Reference: Beaver Valley Power Station, Unit No. 1
Docket No. 50-334, License No. DPR-66
Environmental Qualification of Safety-
Related Electrical Equipment

EQUIPMENT QUALIFICATION ITEMS SUMMARY

JUSTIFICATIONS FOR CONTINUED OPERATION

FIGURE 1
TYPICAL LIMIT SWITCH "SEAL-IN" CIRCUIT
FOR CONTAINMENT ISOLATION VALVE

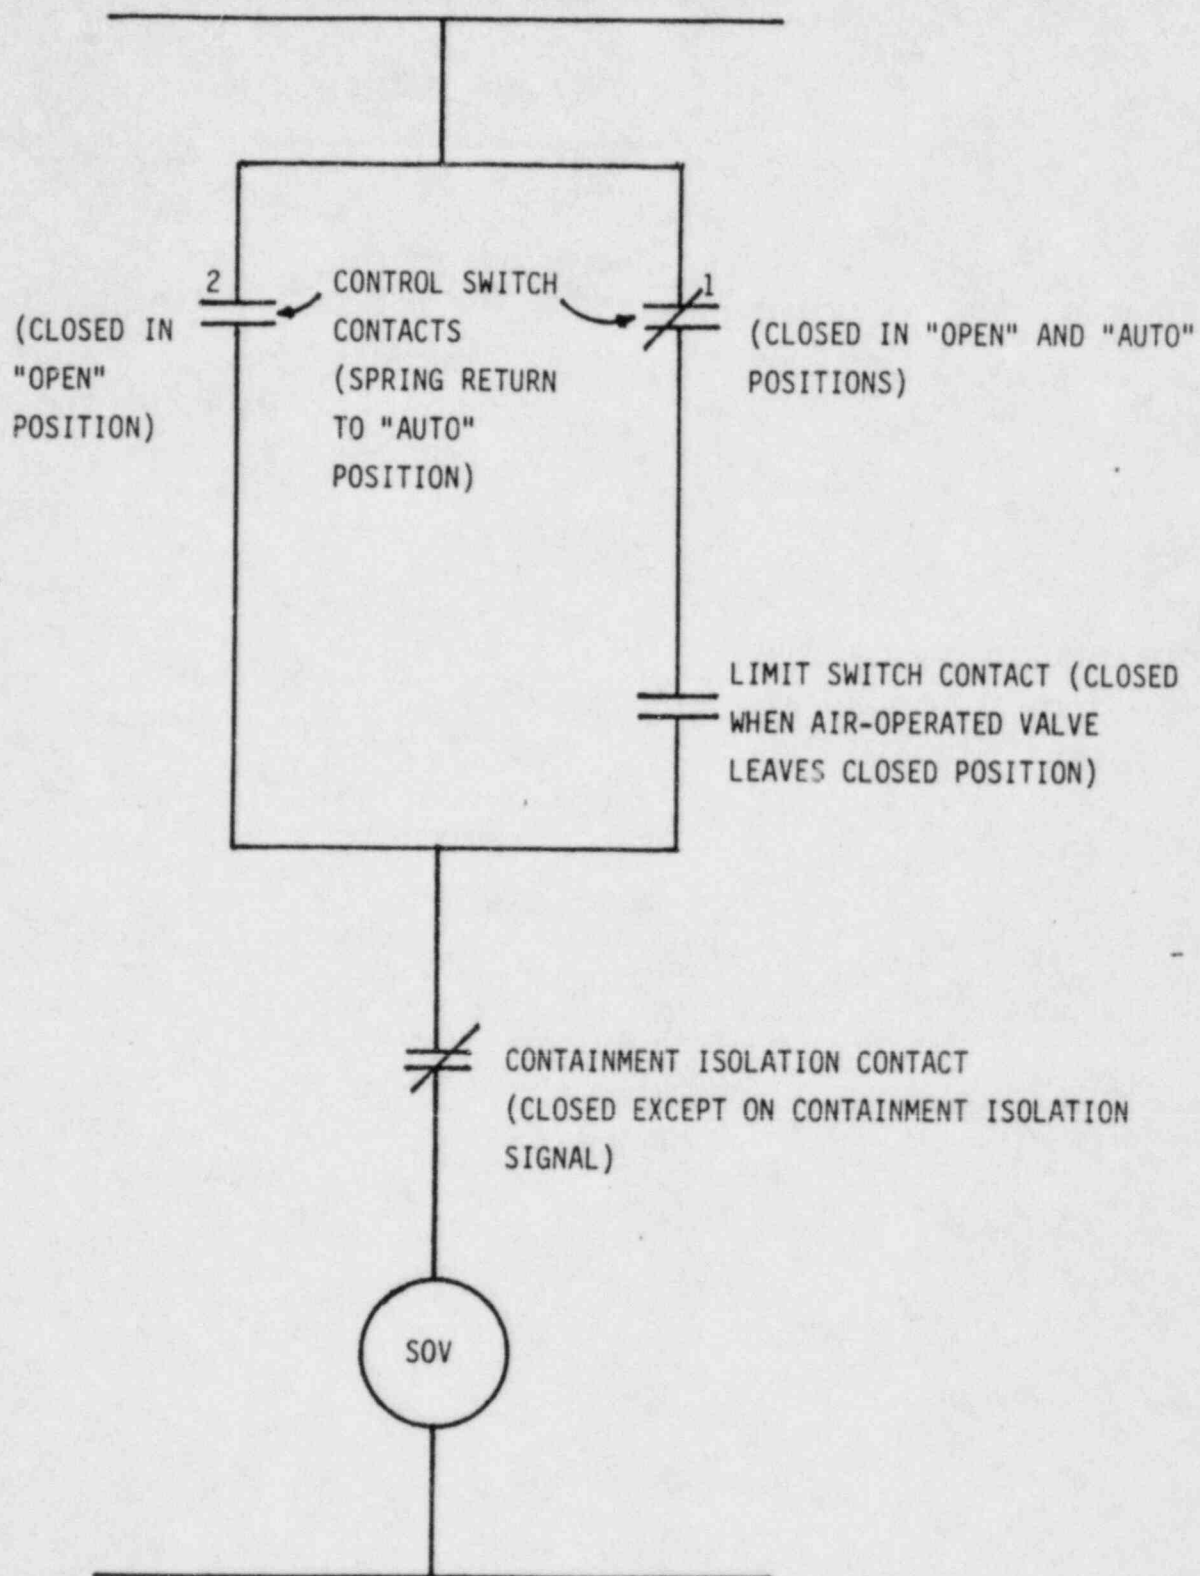
Inadequate steam exposure.

In the event that containment isolation is called for and the limit switch fails closed, the isolation function will be performed as required. However, when the isolation signal is subsequently reset, the failed limit switch would cause its associated solenoid to be re-energized resulting in a re-opening of the air-operated isolation valve (Refer to Figure 1).

FIGURE 1
TYPICAL LIMIT SWITCH "SEAL-IN" CIRCUIT
FOR CONTAINMENT ISOLATION VALVE

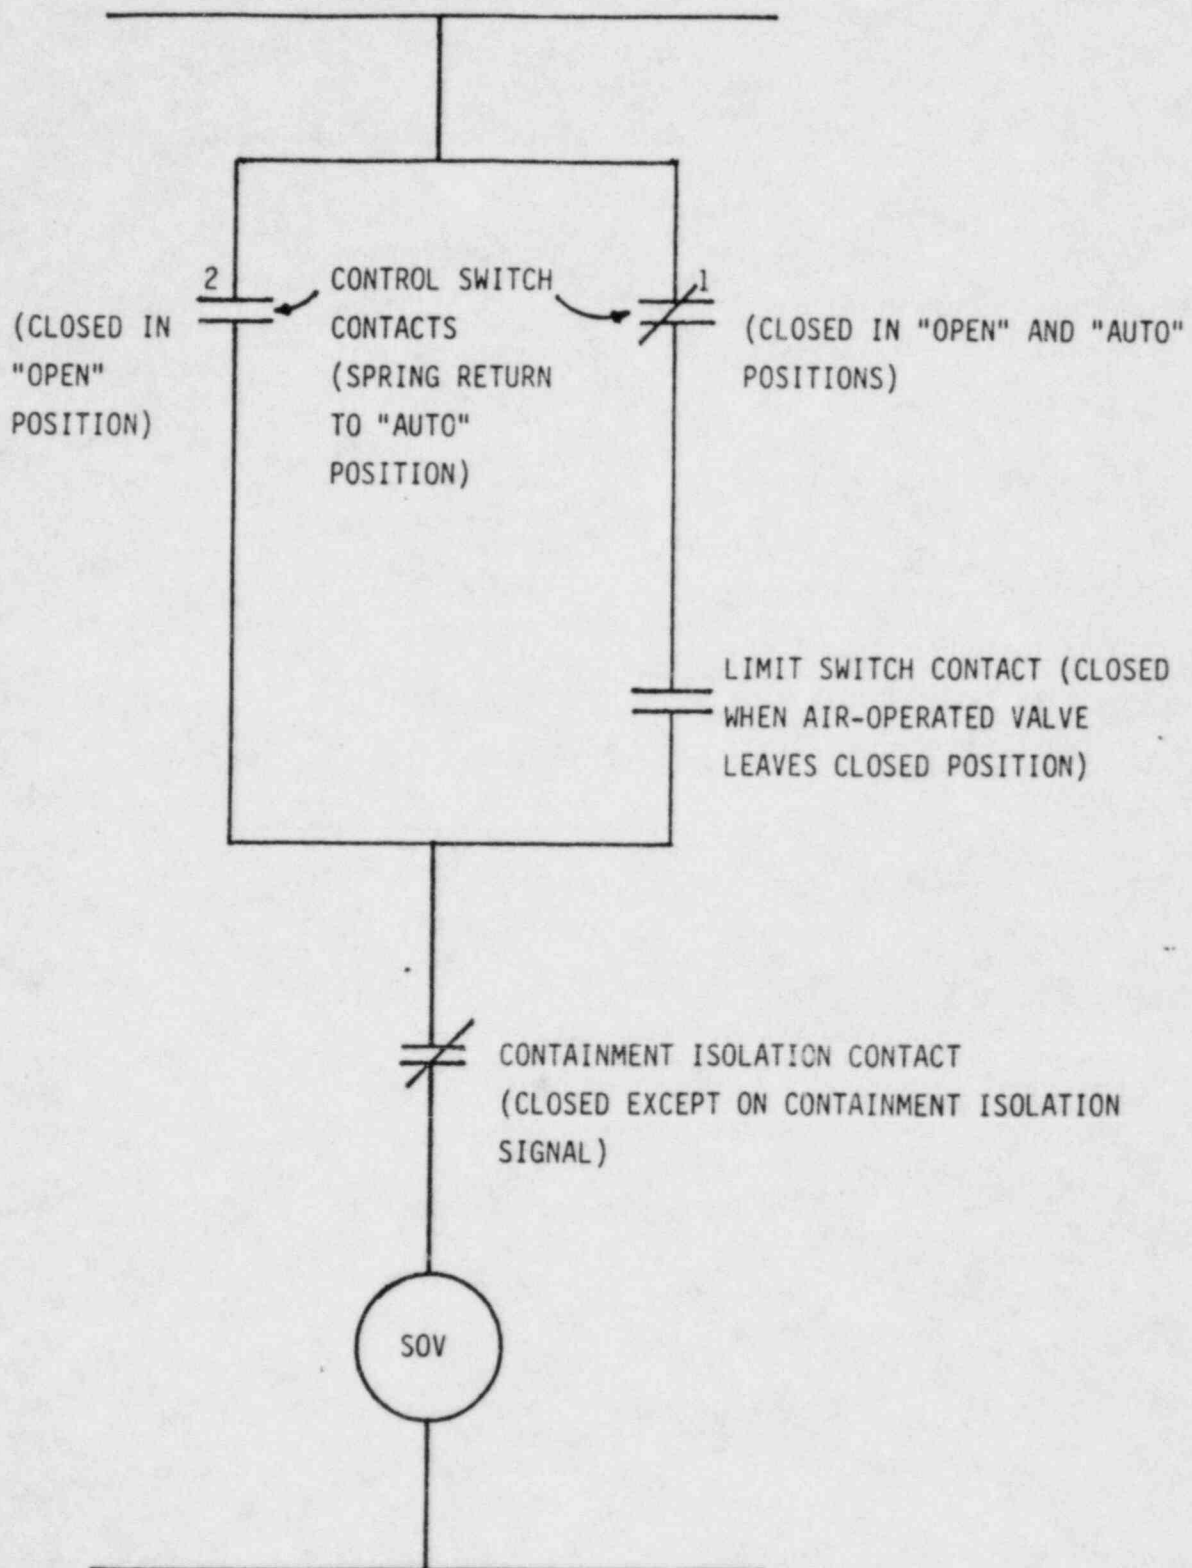
Inadequate steam exposure.

With the solenoid initially energized, limit switch failures will affect the solenoid and air-operated valve as follows. If the switch fails open, it will de-energize the solenoid and cause the associated air-operated valve to go to its fail safe position (closed) and need not be considered any further. A failure resulting in a single ground would have no effect on the battery power supply which is ungrounded. Multiple grounds could result in a trip of the circuit breaker that feeds the solenoid. This failure would cause de-energization of the solenoid resulting in the associated air-operated valve going to its fail safe position (closed) (Refer to Figure 1).

In the event that containment isolation is called for and the limit switch fails closed, the isolation function will be performed as required. However, when the isolation signal is subsequently reset, the failed limit switch would cause its associated solenoid to be re-energized resulting in a re-opening of the air-operated isolation valve (Refer to Figure 1).
